UNITED STATES PATENT AND TRADEMARK OFFICE

Office Action Summary

10/763,985

DETAILED ACTION

FIG.7

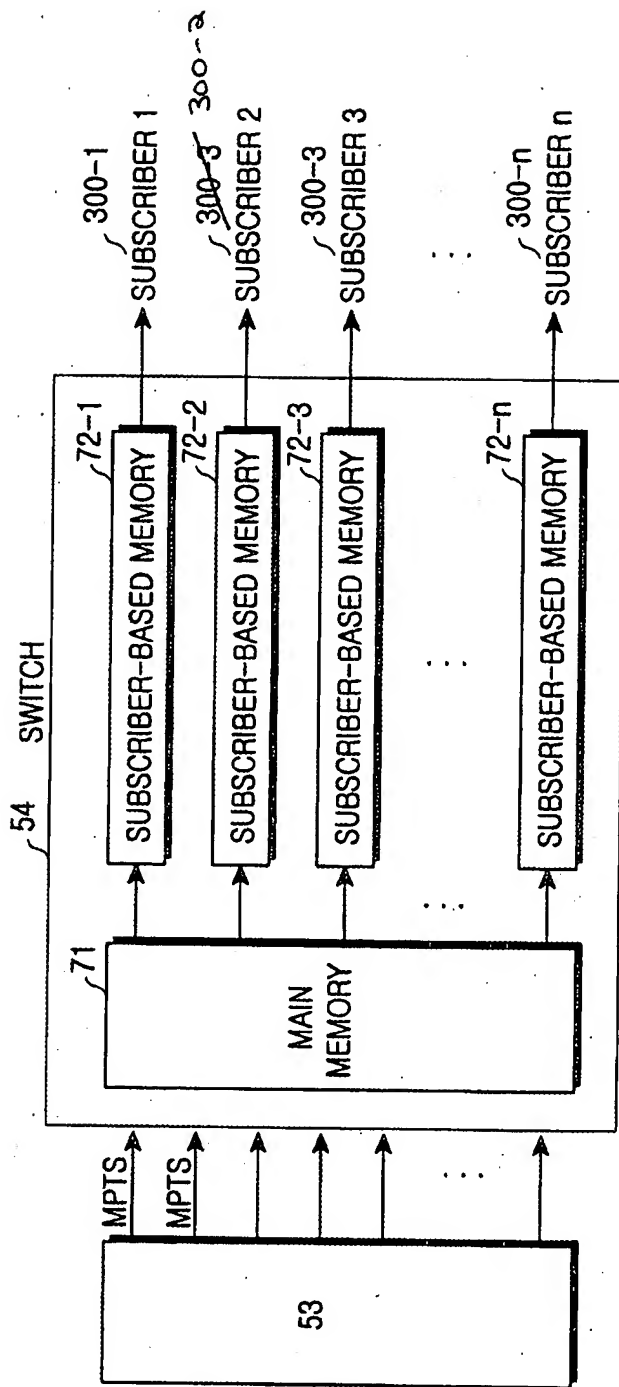
“a plurality of secondary memory units having assigned storage areas for each of the MPTS data and the plurality of subscribers, wherein the **storage areas are** assigned according to the MPTS data in the first memory and **transmitted to each of the plurality of subscribers based upon the MPTS data in the first memory**” (emphasis Examiner’s).

These limitations correspond to Fig. 7 and p. 10, l. 8 – p. 11, l. 13 of the disclosure. Storage areas are not generally known to be *transmittable*. Rather, the MPTS data is transmittable. Furthermore, the disclosure does not support the transmission of storage areas. Accordingly, this limitation is not enabled. As a remedy, Examiner respectfully suggests amending the claim language so that the MPTS **data** is transmitted instead of the storage areas.
